Update: Replacement "G" series tank kit 970419 available STOP SALE / RENTAL NOTICE

Bulletin No: JC-003-2011 REV1

Issue: Fuel Tank Recall "G" series Walk-Behind Mowers

SCHILLER	BOB-CAT Gear Driv tank replacement in	e walk-behind G series structions.	Tool List: Needle nose pliers, 9/16" wrench, Torque Wrench.
	Covers: 932007G, 933007G, 934007G		
		Rev: A

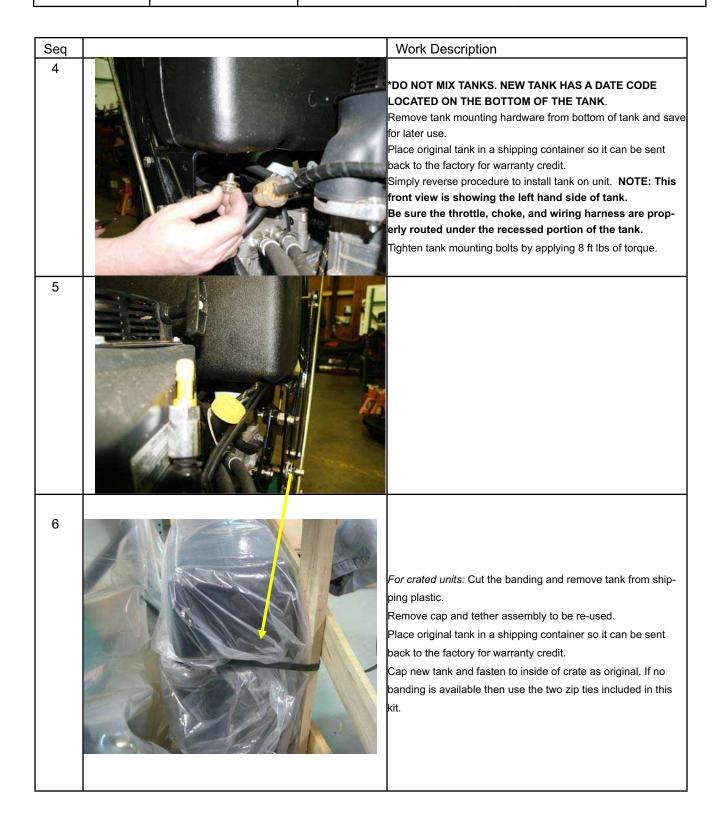
Fuel tanks are leaking fuel around the mounting inserts in the bottom of the fuel tank. Units should not be fueled or operated.

Cause: The wrap material used in the assembly process to provide a seal around the mounting inserts was improperly applied by the supplier. The supplier also failed to pressure test each fuel tank as required.

Action Required Addendum: Due to a supplier shortage on the original EPA compliant gas tank, Schiller Grounds Care provided, on a limited basis, kits (970418) to convert the "G" series units to EPA Non-Compliant "F" series units. Any unused 970418 kits can be returned. We are happy to report that the EPA compliant tank is now readily available as **Kit 970419**. Any remaining inventory should be updated using this kit.

Seq	Work Description
1	If working on a unit already setup by the dealer, follow se- quence 1 thru 5 if working on a crated unit see step 6. Remove purge hose from black plastic tank valve.
2	Remove fuel line from metal tank supply fitting.
3	Remove cap and tether assembly from tank to be re-used.
